AVIATION TECHNICAL BULLETIN

Champion Spark Plug Company

NO. 67-4
CONTROLLED
COPY

HAVING SPARK PLUG FOULING IN YOUR CONTINENTAL 10-520 ENGINE?

MODEL 10-520
6 cyl., 520 cu. in. disp.
285 hp @ 2700 rpm

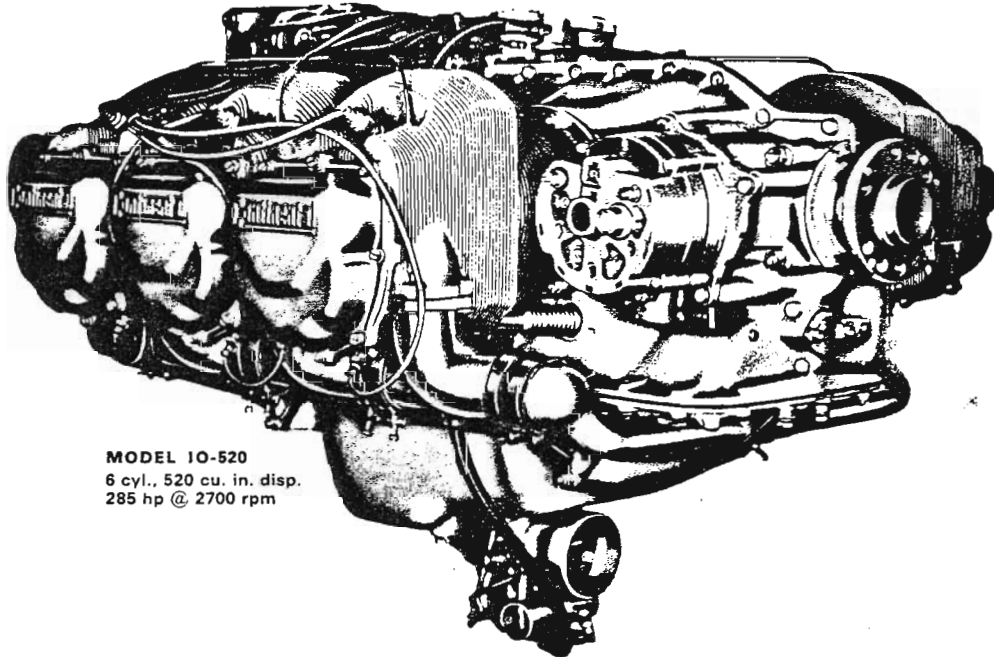
Then may we suggest you try the CHAMPION RHB32E Spark Plug.

Many operators are reporting excellent results after changing to the RHB32E plug. The plugs are readily available through your local Champion supplier.

Note: This plug replaces the RHB32N and RHB33E spark plugs and is approved wherever they have been approved. Of course, the fine-wire spark plugs RHB32P and RHB32W are also approved in this engine.
